AMENDMENT 1
2019-08

**Harvesting equipment — Blades
for agricultural rotary mowers —
Requirements**

Reference number
ISO 5718:2013/Amd.1:2019(E)

AMENDMENT 1

Figure 4

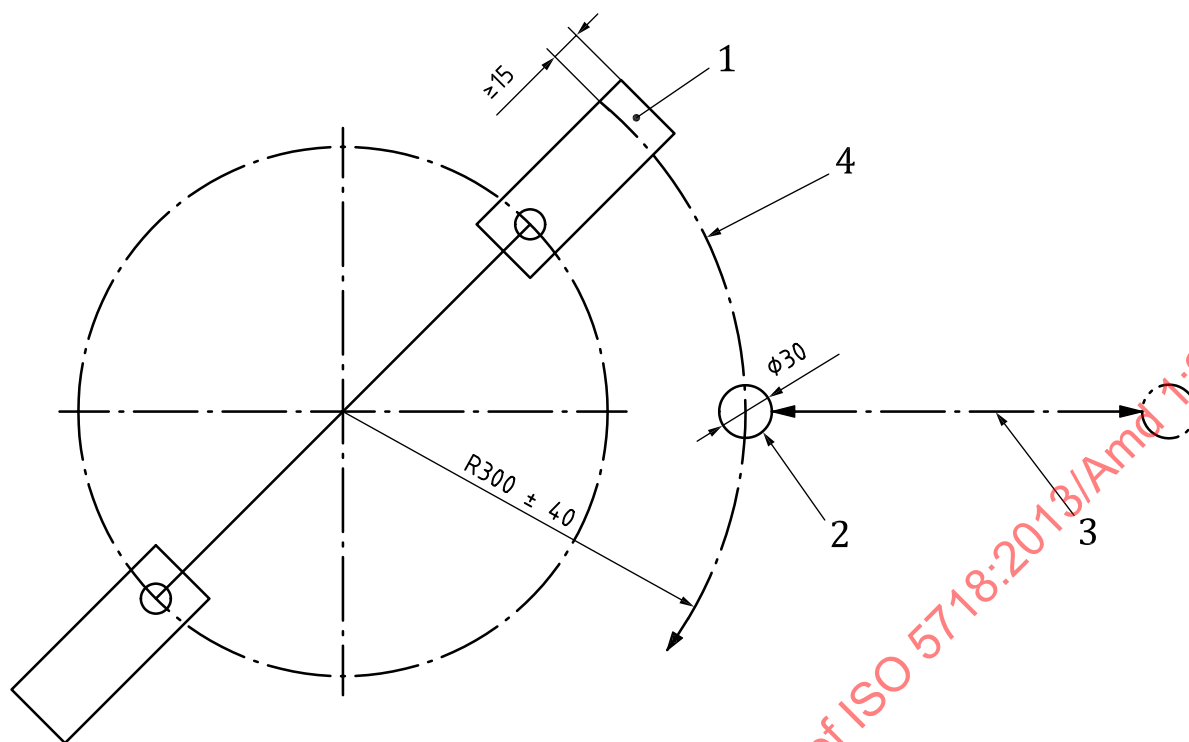
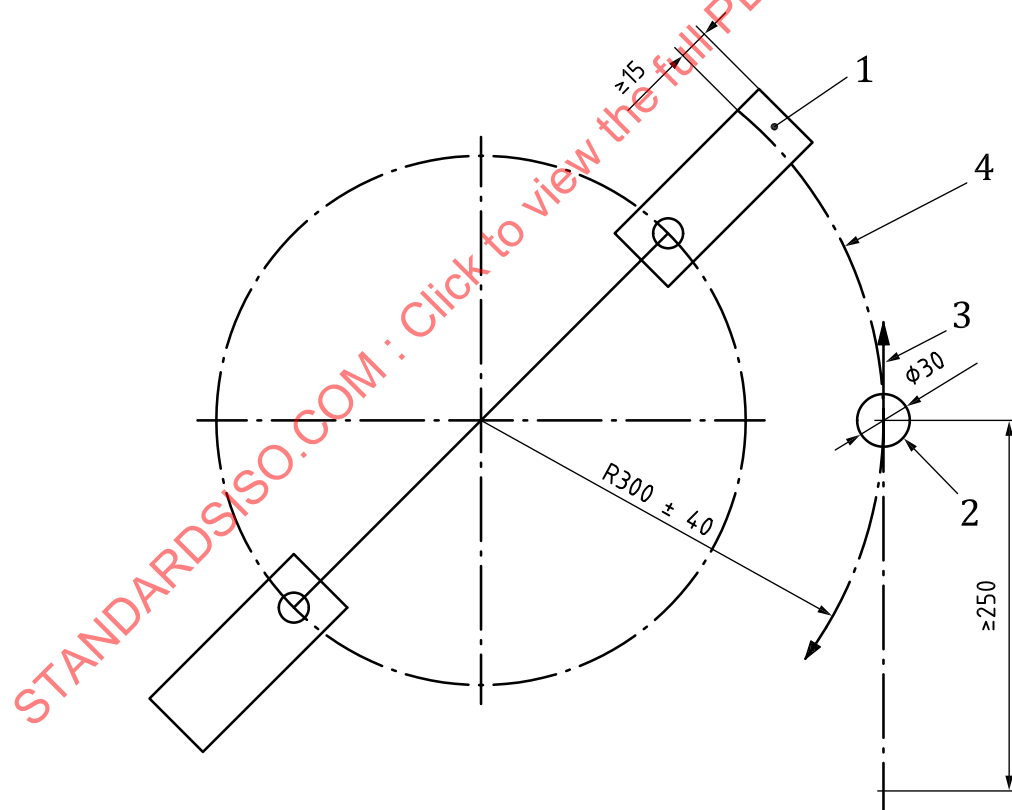
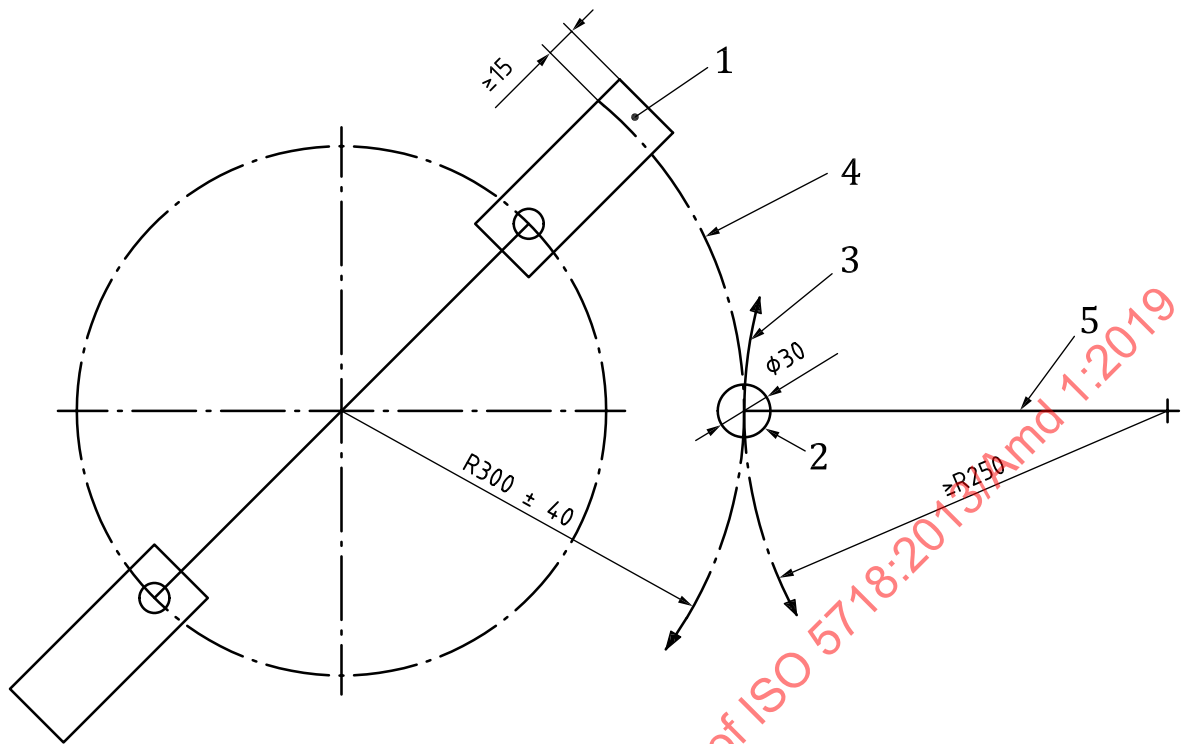
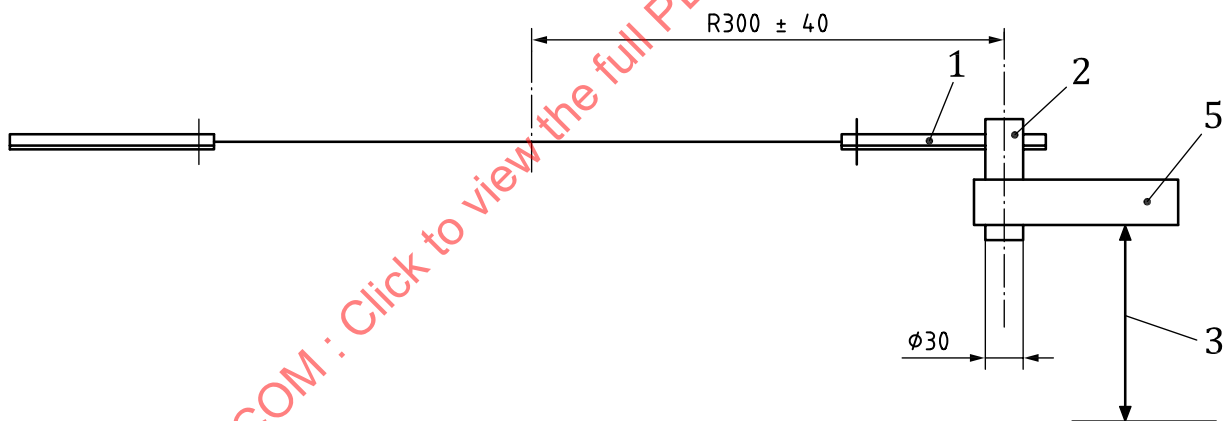
Replace Figures 4 a), b) c) and d) by the following:

a) Steel rod insertion on a straight line perpendicular into the path of the blade

b) Steel rod insertion on a straight line tangential into the path of the blade

c) Steel rod insertion on a circular line into the path of the blade

d) Steel rod insertion on a straight line from below into the path of the blade

All blades selected for impact testing shall be tested on a test fixture as shown in Figure 4.
